From: EARLS, Chris [cee@nei.org]
Sent: Friday, August 08, 2008, 6:42 AM
To: Ram Subbaratnam, *NRO*
Cc: Nilesh Chokshi; BELL, Russ; KASS, Leslie [redacted]_oob@rpconstruct.com; HEYMER, Adrian; BELL, Russ; Kassawara, Bob; Moore, Don P.; Ostadan, Farhang; EARLS, Chris
Subject: Meeting on ISG Section 3
Attachments: seismic ISG May 2008-Marked.rtf; GSto40_Spectra-1.doc

**Interim Staff Guidance on Seismic Issues Associated with High Frequency Ground Motion in
Design Certification and Combined License Applications**

Study of Alternative Methods to Develop Input Motion for SSI Analysis

DE-CONVOLUTION ANALYSIS USING GMRS AS INPUT MOTION

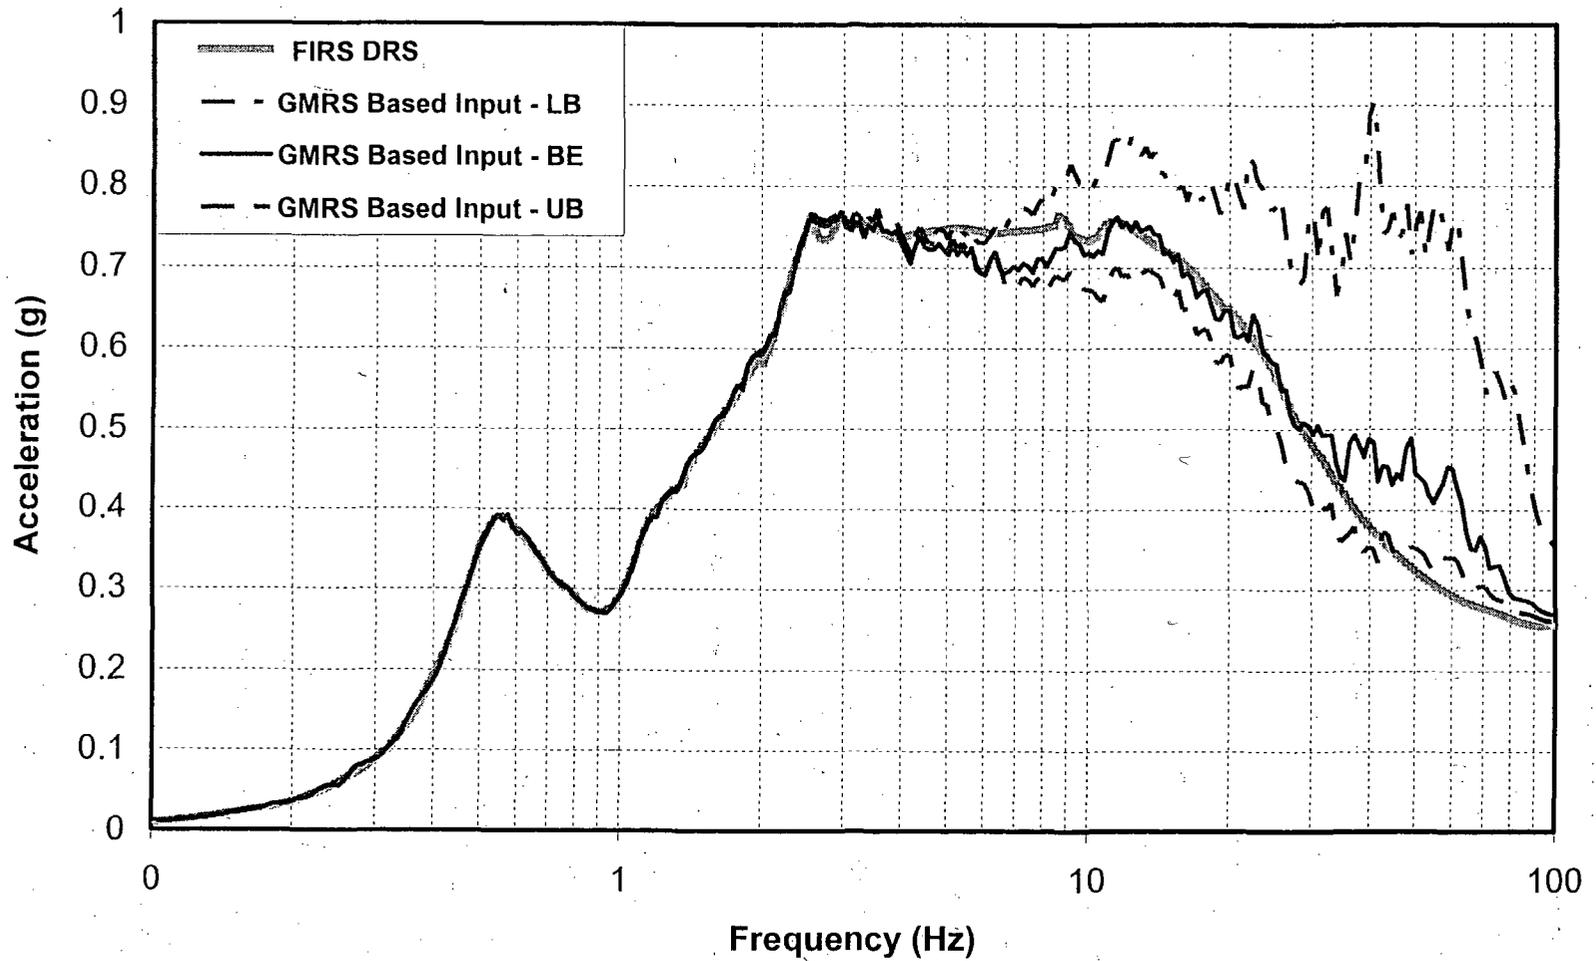
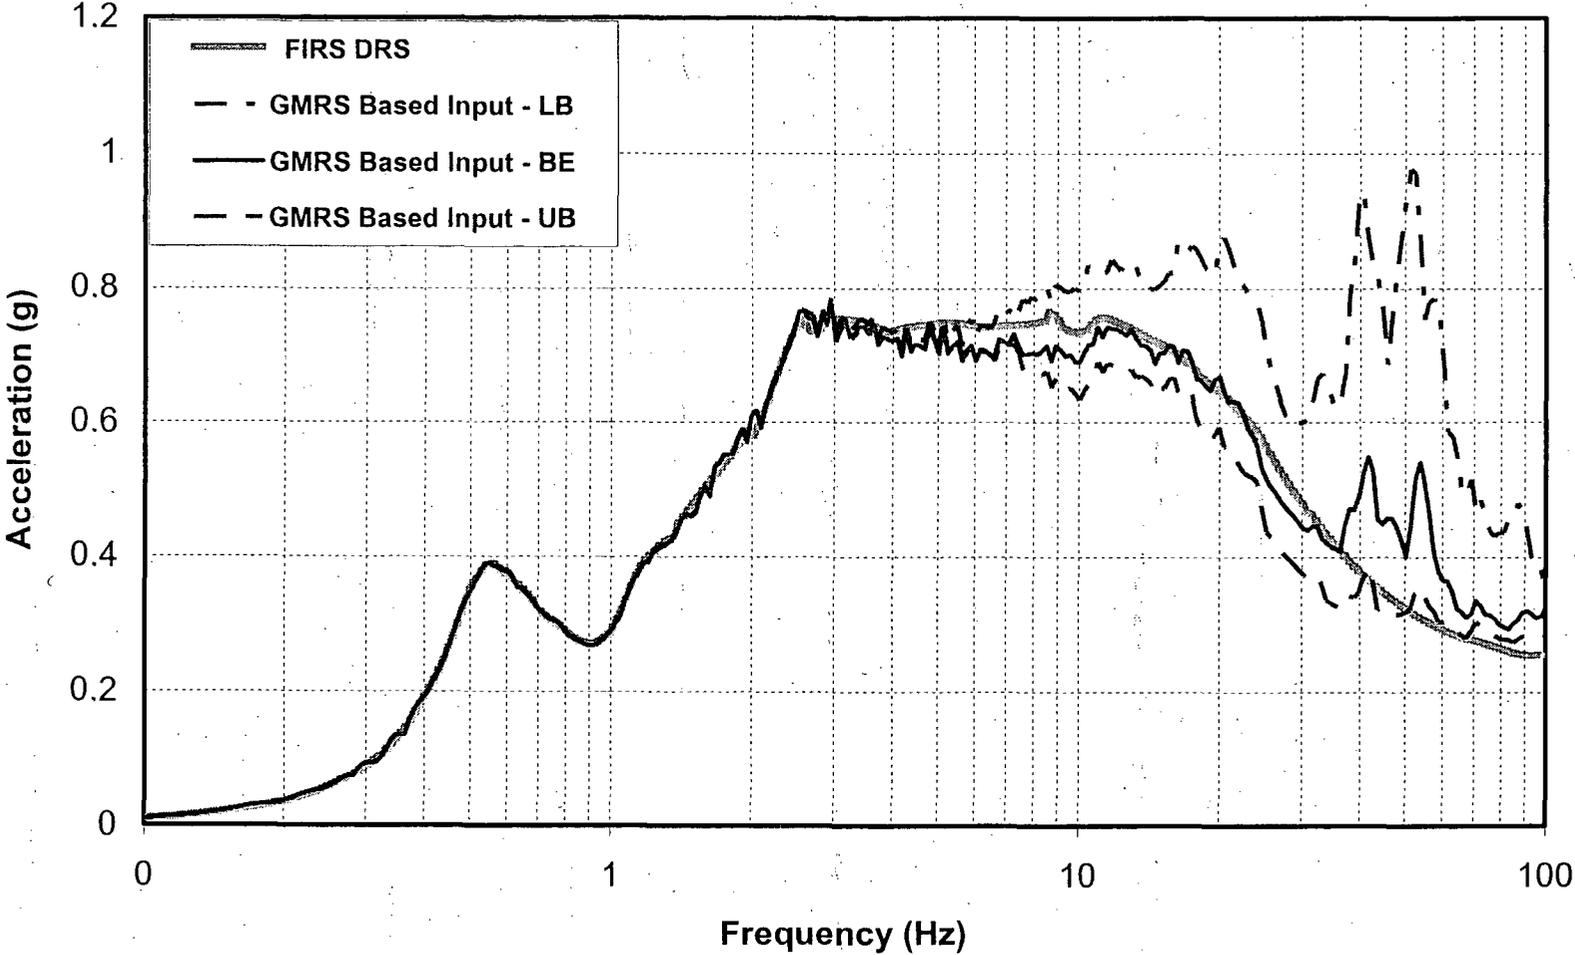
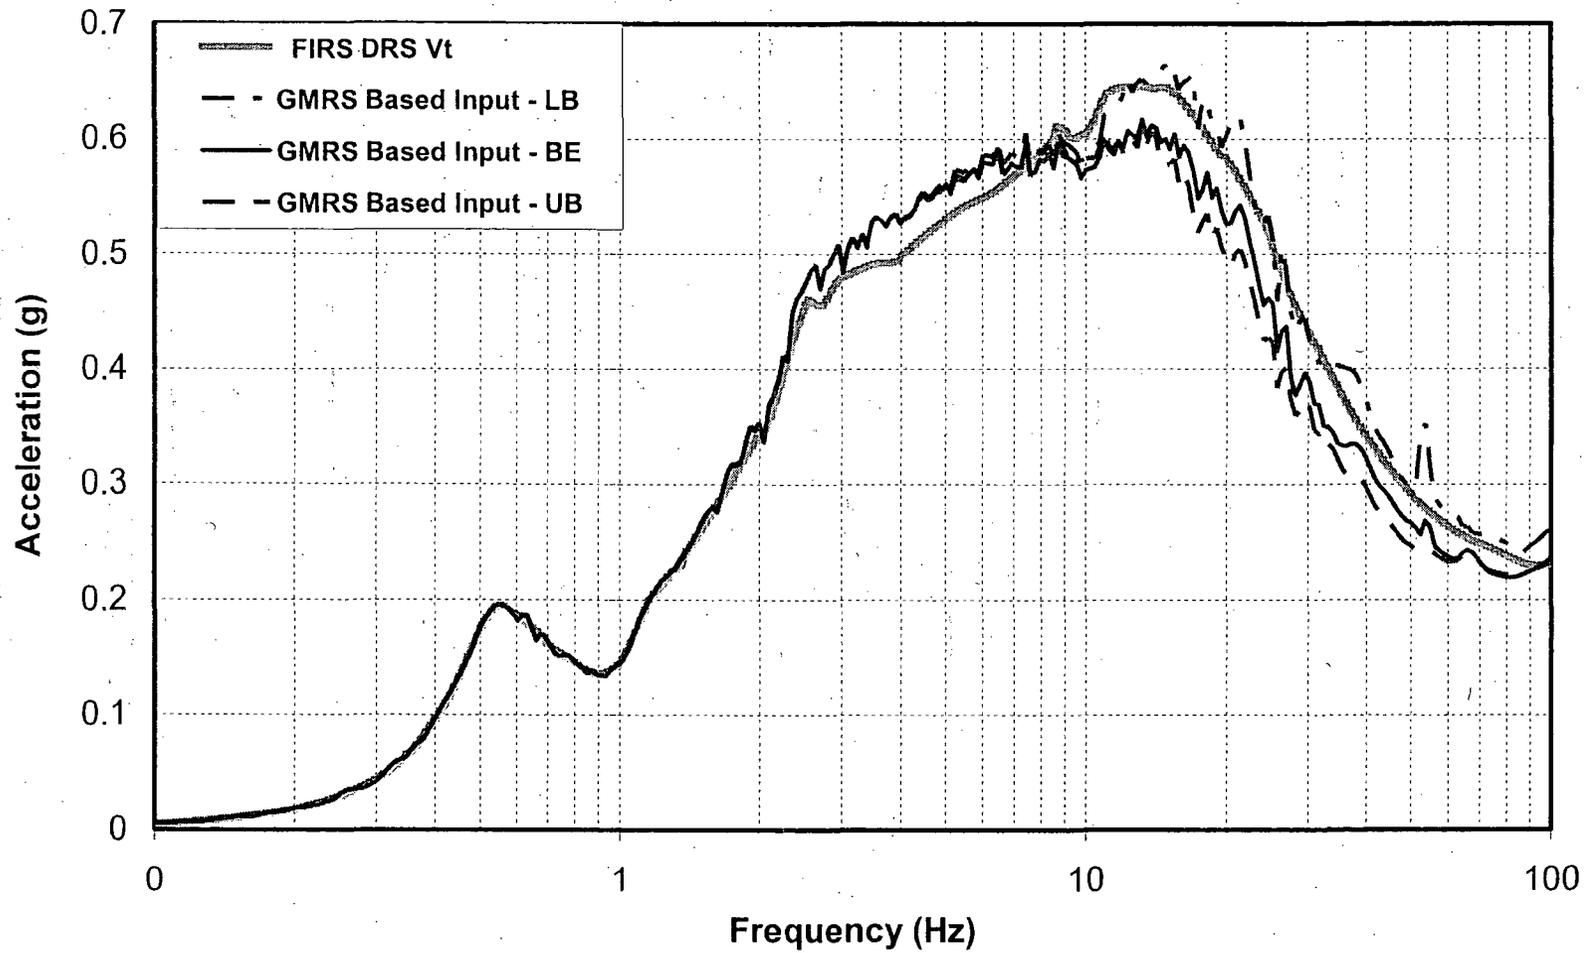
- **GMRS is a broad band spectrum that includes the effects of a range of randomized soil profiles with high frequency contents controlled by the stiffer soil profiles. De-convolution of the broad band spectrum particularly in the softer set**

of soil profiles results in unrealistic ground motion at depth (see the example).

- Development of the ground motion (GMRS and FIRS) can be based on one full height soil column profile. The column in its full height can be used to obtain GMRS as "SHAKE outcrop" at the top of the competent soil layers. The same analysis also generates the outcrop motion at any other horizon that FIRS is needed for structural analysis.

- Development of GMRS and FIRS based on the same soil column using convolution analysis avoids issues with de-convolution analysis of a broad band spectrum.

COMPARISON OF THE RESULTS FROM TWO METHODS

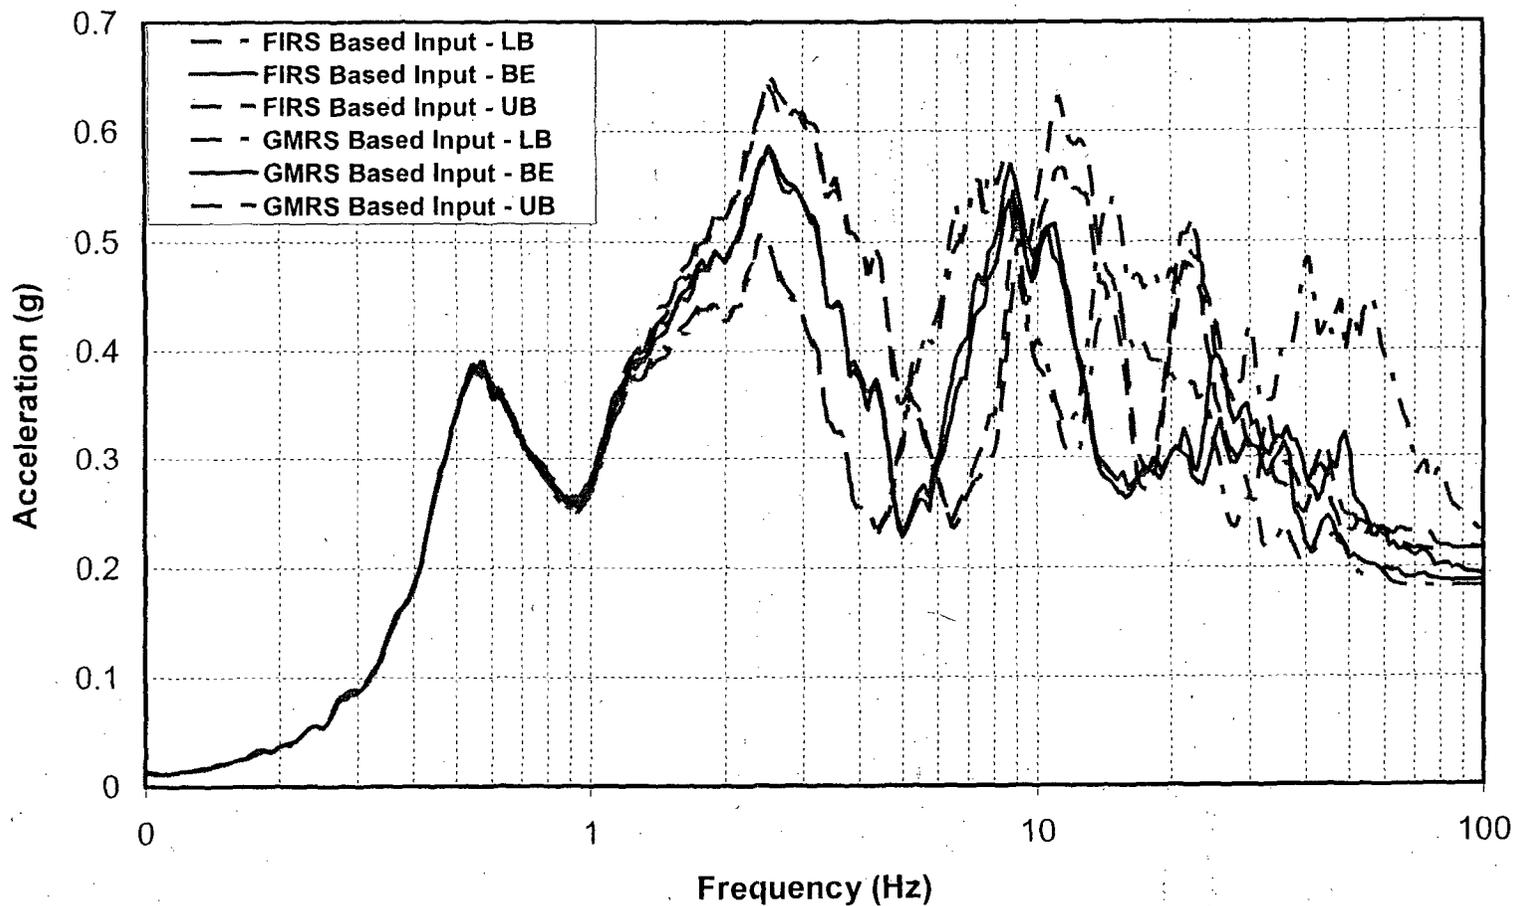
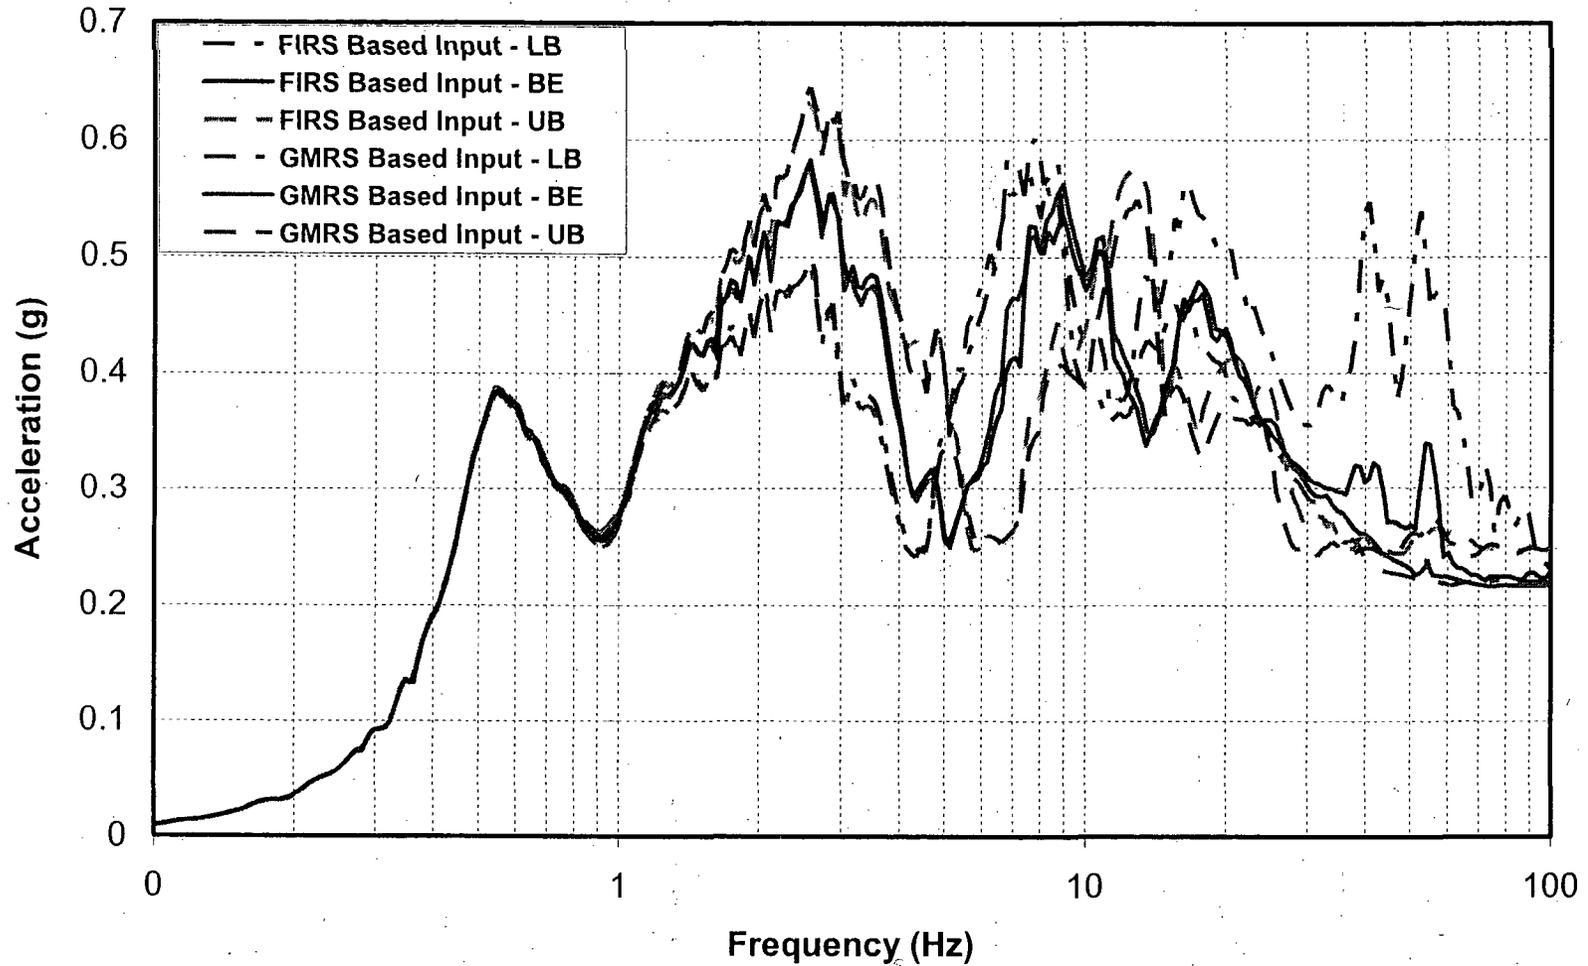
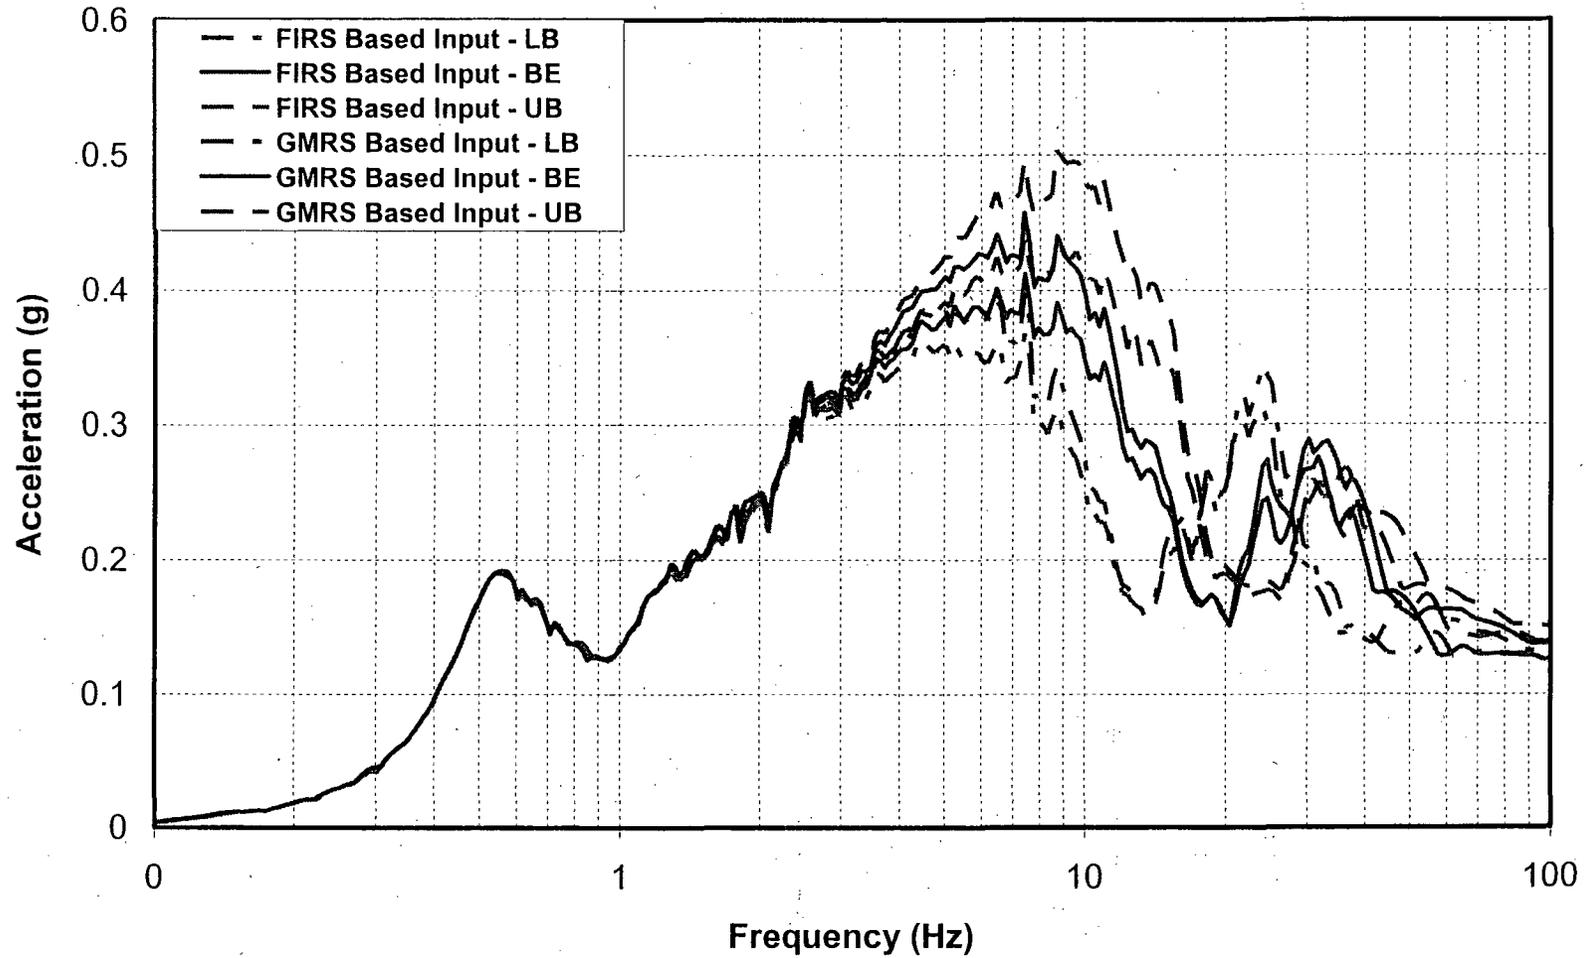
1. Developing input motion for SSI analysis using FIRS as outcrop motion as defined by the program SHAKE results in adequate characterization of the ground motion at the foundation level and along the embedment depth of the structure comparing favorably with GMRS at the ground surface.
2. The entire soil profile can be used to develop FIRS and GMRS. As long as the 3 profiles selected for SSI analysis are obtained from the same set used for generation of GMRS/FIRS, the modeling of ground motion will be fully consistent with SSI analysis.
3. The HF part of the GMRS at the ground surface is the result of stiffer soil columns used to generate the GMRS. De-convolution of GMRS particularly for the lower bound soil profile results in unrealistic ground motion at the depth even at shallow depth of foundation.
